# **FIRE SAFETY INSPECTION REPORT**

## **UNION GARMENTS LTD.**

April 3, 2014

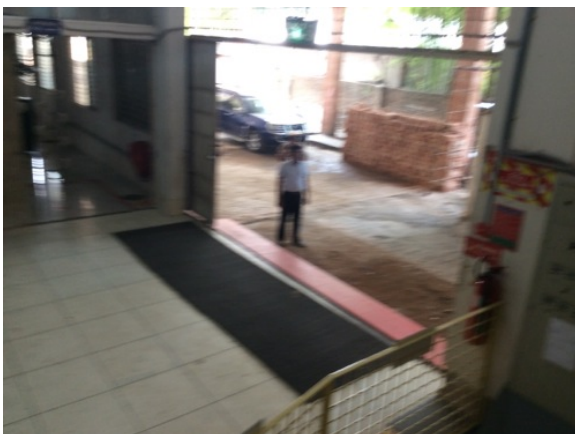
F-2	Fire Rated Construction	Unsealed penetrations and openings are located in exit stair enclosures.	Seal all penetrations and openings in exit stair enclosure walls to maintain the fire separation.	Within 3 months
-----	-------------------------	--	---	-----------------
